Subject: SQUEAKING NOISE FROM SUNROOF	Bulletin No: 09-029/06
	Last Issued: 07/12/2006

APPLICABLE MODEL(S)/VINS

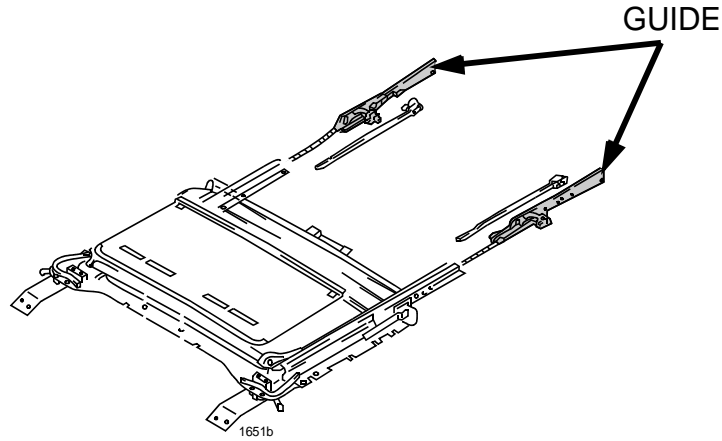
Some vehicles may exhibit a squeaking noise from the sunroof rail or guide when driving with the sunroof open. This squeaking noise is most likely caused by a looseness due to wear between the sunroof guide pin and the cam groove. To prevent this wear, the material and shape of the sunroof guide pin has been modified.

3. Replace both sunroof guides with modified ones according to Workshop Manual for Mazda5 (section 09-15 SUNROOF UNIT DISASSEMBLY/ASSEMBLY) or for Mazda RX-8 (section 09-15 SUNROOF UNIT DISASSEMBLY/ASSEMBLY).

Part Number	Description	Qty.
F153-69-862A	Guide (R)	1
F153-69-863A	Guide (L)	1
